**DEPARTMENT OF TRANSPORTATION**

Contract #: 04-0120F4Cty: SF/ALA Rte: 80 PM: 13.2/13.9File #: 69.25B**QUALITY ASSURANCE -- NON-CONFORMANCE REPORT****Location:** Changxing Island, Shanghai, P.R. China**Report No:** NCR-000420**Prime Contractor:** American Bridge/Fluor Enterprises, a JV**Date:** 26-Aug-2009**Submitting Contractor:** Zhenhua Port Machinery Company, Ltd (ZPMC), Changxing Island**NCR #:** ZPMC-0394**Type of problem:**

**Reference Description:** Heat Straightening not according to the Heat Straightening Procedure**Description of Non-Conformance:**

**Job Name:** SAS Superstructure

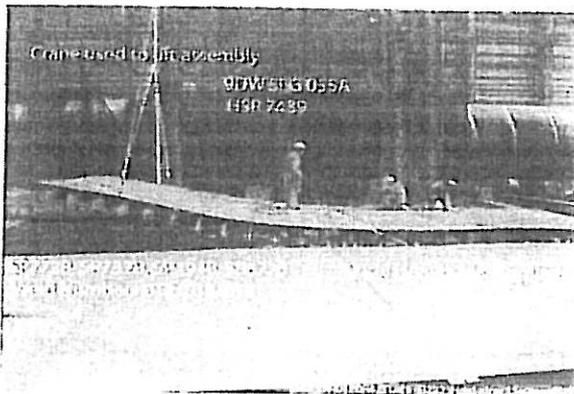
This Quality Assurance Inspector (QA) observed that the contractor is deviating from the AWS D1.5 Code requirements for heat straightening. The contractor used an overhead crane to lift one end of a side panel while local heat was being applied. This method deviated from the ZPMC Heat Straightening Report (HSR1) #7439. The side panel in question is for OBG Segment 9DW (SEG 055A) with Side Panels designation SP772B, SP732B, SP494B, and SP672B. The weld being heated in the photograph below is weld number 013.

Applicable reference: AWS D1.5 Section 3.7.3: "Members distorted by welding shall be straightened by mechanical means or by carefully supervised application of a limited amount of localized heat as approved by the Engineer. The temperature of the heated areas as measured by approved methods shall not exceed 600°C [1100°F] for quenched and tempered steel nor 650°C [1200°F] (a dull, red color) for other steels. The part to be heated for straightening shall be substantially free of stress and from external forces, except those stresses resulting from the mechanical straightening method used in conjunction with the application of heat."
